SUBMITTAL OF WORK PLAN FOR ZONE H OTHER IMPACTED AREAS GRIDS G07 AND  
038 WITH TRANSMITTAL CNC CHARLESTON SC

**INTERIM MEASURE FOR ZONE H  
OTHER IMPACTED AREAS (OIAs)  
GRIDS G07 and G038  
CHARLESTON NAVAL COMPLEX  
CHARLESTON, SC**

Subj.: SUBMITTAL OF REVISIONS TO WORK PLANS FOR OTHER IMPACTED AREAS (OIA) GRID G07, GRID G038 AND AOC 684

**South Carolina Department of Health and Environmental Control comments on: Interim Measures Work Plan for Other Impacted Areas (OIAs) Grid G07 and Grid G038; dated June 29, 1999; Located in Zone H Charleston Naval Complex SCO 170 022 560.**

**Figure 3 PCB EXCAVATION AREA**  
Zone H Grid G07  
BUILDING 644  
Naval Base Charleston, SC

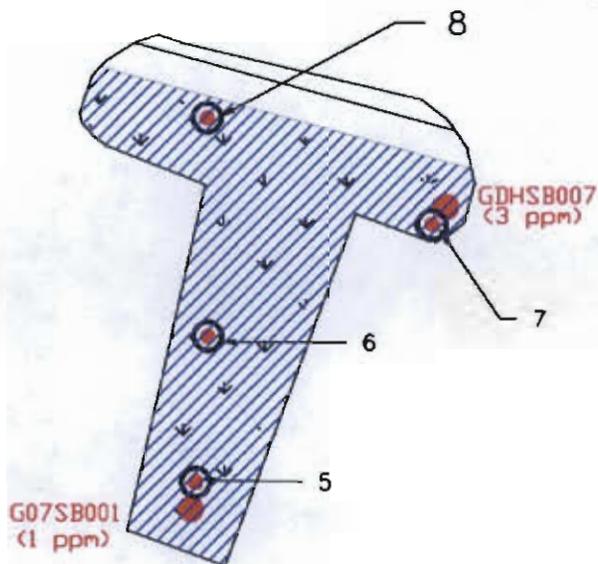
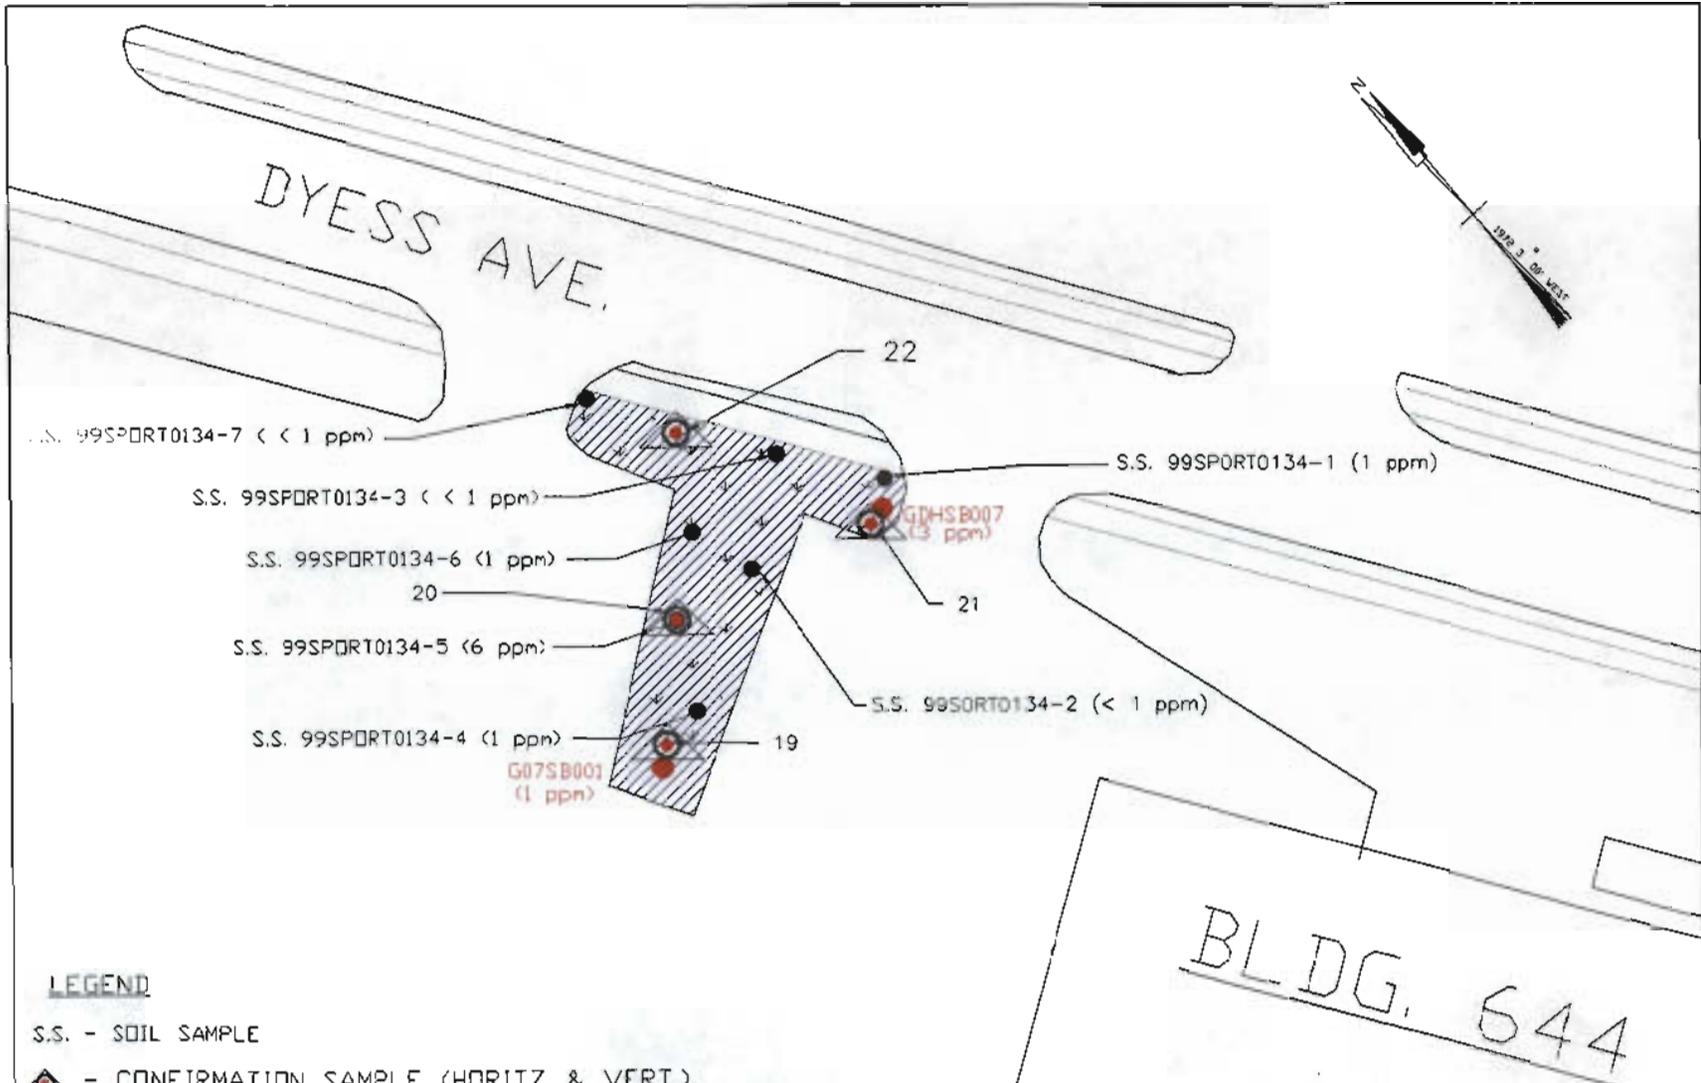
4	DHEC Bergstrand	5. This section states "The extent of the excavation...at location G07 shown in Figure 3 of Appendix D.... (and)...at location G038 shown in Figure 4 of Appendix D..." The extent of excavation is not clearly indicated on either figure. Please revise these two figures. The two revised figures may be submitted to be included in the workplan. The two revised figures should be submitted before the document can be approved.	Vertical excavation and confirmation will continue until the objective of this IM is met or ground water is encountered. As shown in figures 3 and 4 horizontal confirmation and excavation will continue up to the asphalted areas. Should the sample results exceed the objective of this IM plastic sheeting (6 mil thk.) will be placed along the sidewalls. The excavation will be backfilled and the conditions documented in the completion report. Further investigation will be warranted to determine the extent of additional cleanup.

This section states "The extent of the excavation...at location G07 shown in Figure 3 of Appendix D.... (and)... at location G038 shown in Figure 4 of Appendix D..." The extent of excavation is not clearly indicated on either figure. Please revise these two figures.

**Figure 4 PCB EXCAVATION AREA**

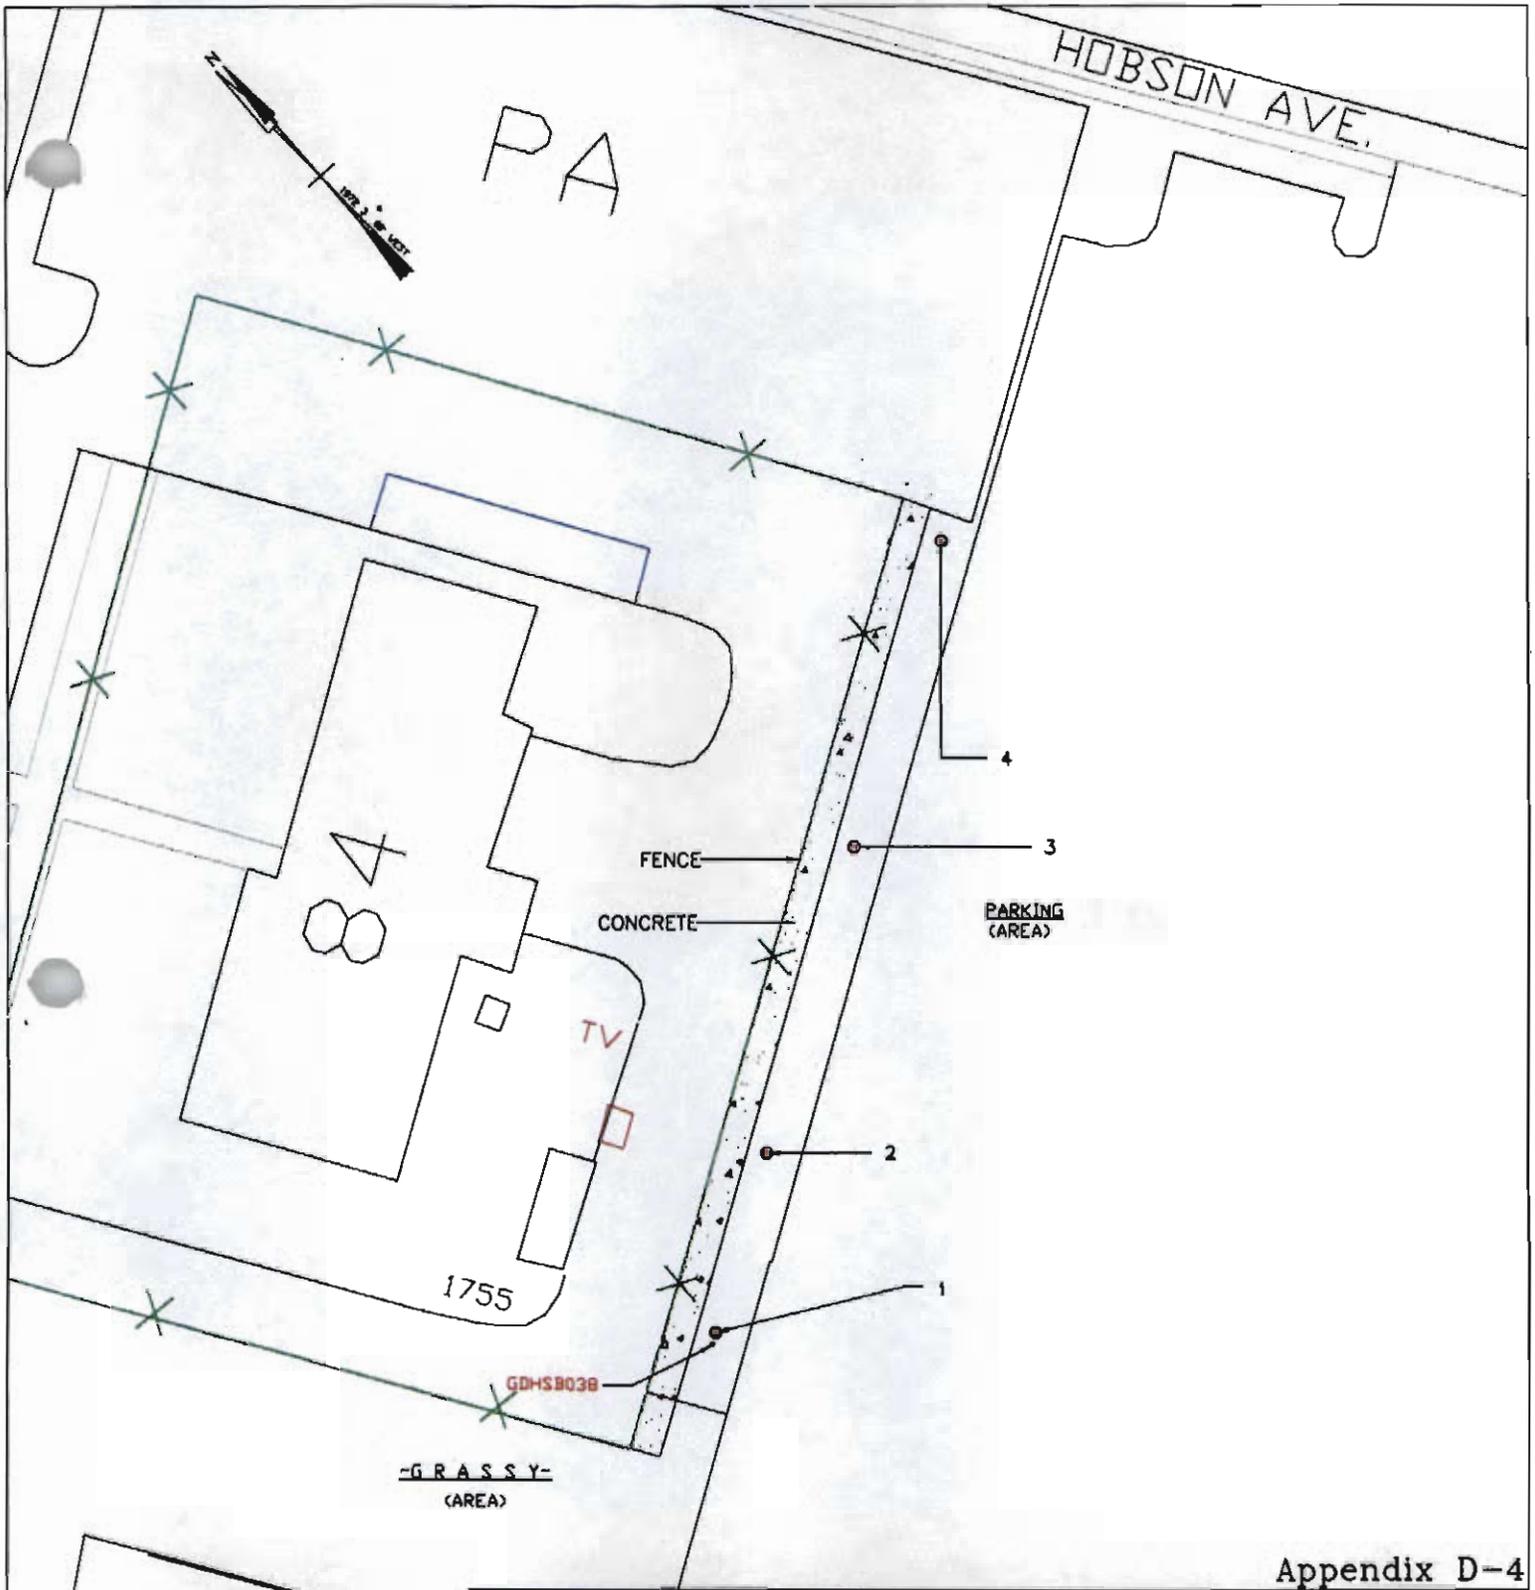
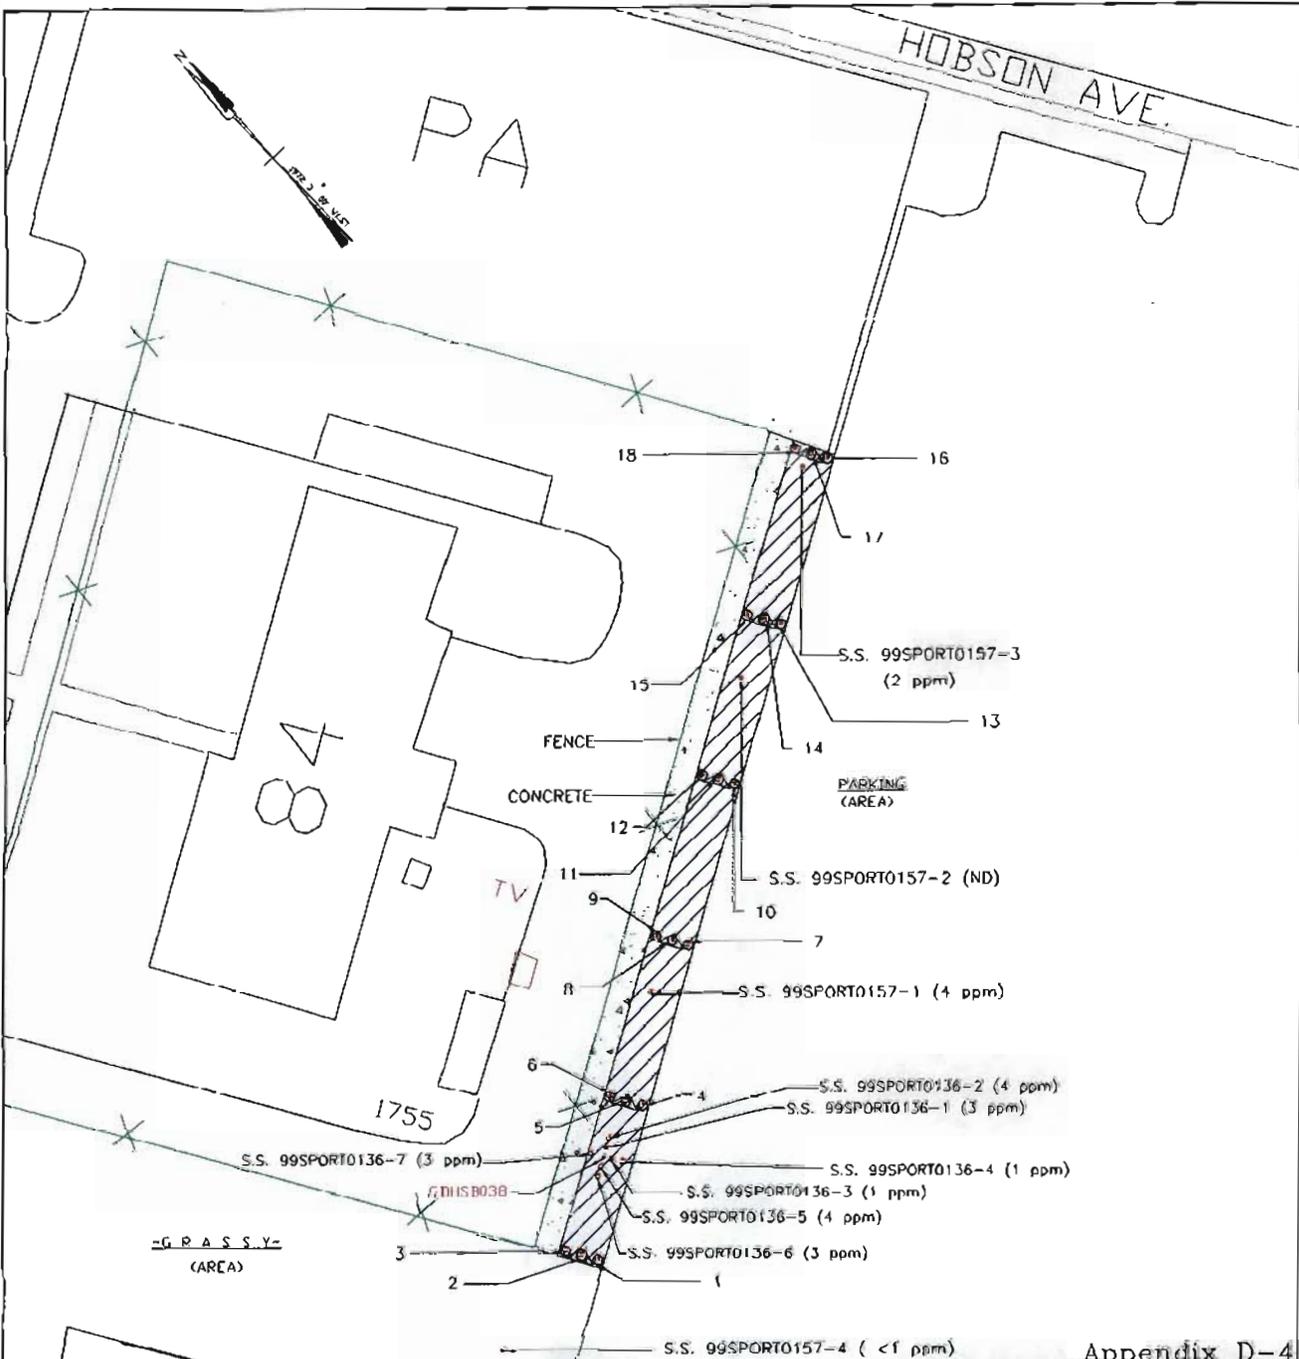
Please revise this section to address this concern.
3. Appendix A; 1. Site History; page A-1.  
Please provide brief description and figure to orient the sites (G07 & G038) within Zone H and with respect to SWMU or AOC within which the RFI sampling was conducted.
4. Figure 3 and 4; PCB Excavation Area for Grid07 and G038  
Section 4, page 2, fourth line states that, "Samples collected to delineate the site horizontally will be used to confirm the horizontal extent of excavation."  
The referenced figure does not show any sample locations to confirm the horizontal extent of excavation. Please revise these figures to address this concern. Please show the excavation area for G038 on Figure 4.

The two revised figures may be submitted to be included in the workplan. The two revised figures should be submitted before the document can be approved.

FIGURE 4.23.1  
 SOIL SAMPLE LOCATIONS IN  
 OTHER IMPACTED AREAS

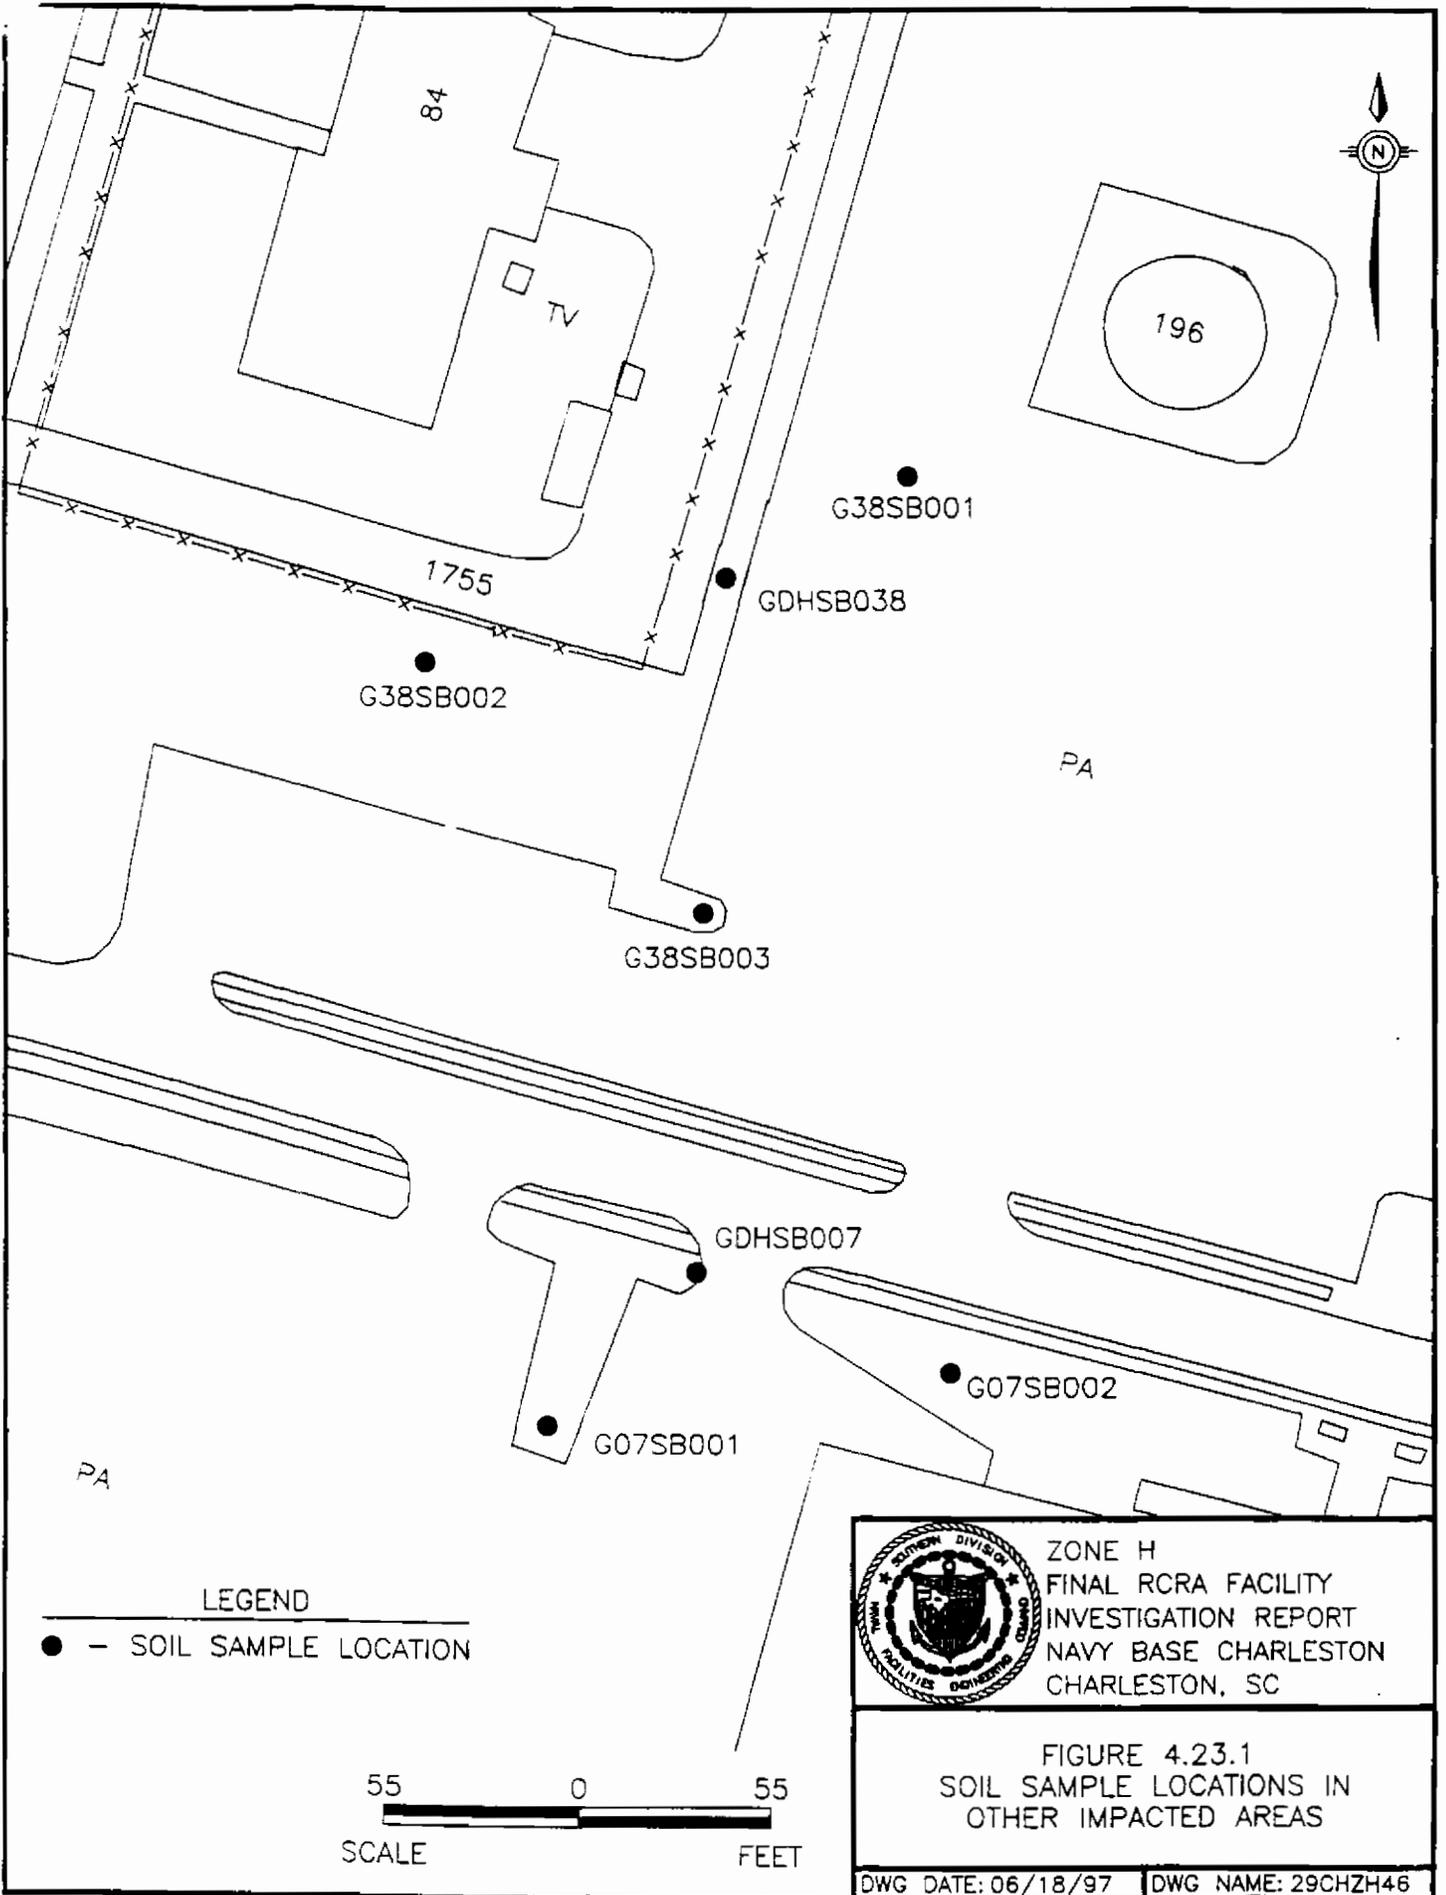
App. A	DHEC Mehta	3. Please provide a brief description and figure to orient the sites (G07 & G038) within Zone H and with respect to SWMU or AOC within which the RFI sampling was conducted.	<b>App. A</b> Section 4.21 of the Zone H RFI dtd 31 July 1995 states "For the purpose of obtaining data to be used for the determination of background or upper tolerance limit concentrations for select compounds and elements, soil and groundwater samples were collected at grid-based locations across Zone H. This statement and drawing A-3 will be added to appendix A to clarify the site orientation.
Figure 3 and 4; 4.0	DHEC Mehta	4. Figure 3 and 4; PCB Excavation Area for Grid G07 and G038. Section 4, page 2, fourth line states that, "Samples collected to delineate the site horizontally will be used to confirm the horizontal extent of excavation." The referenced figure does not show any sample locations to confirm the horizontal extent of excavation. Please revise these figures to address this concern. Please show the excavation area for G038 on Figure 4.	<b>Section 4.0</b> Figures 3 and 4 are revised for clarification Soil boring results of less than 10 ppm taken in 1996 and 1999 will be used to define the horizontal extent of the excavation boundaries. These locations are depicted by solid red dots in revised figures 3 and 4. The data gaps from the 1999 soil sampling along the excavation boundaries will be confirmed in the areas as shown in 50 foot intervals in the revised figures. Confirmation of the vertical extent is indicated with triangles in the revision. Samples 10 thorough 20 as shown in figure 3 will be for both horizontal and vertical confirmation. These samples will be collected at the end of the project and will be used verif the effectiveness of the removal.
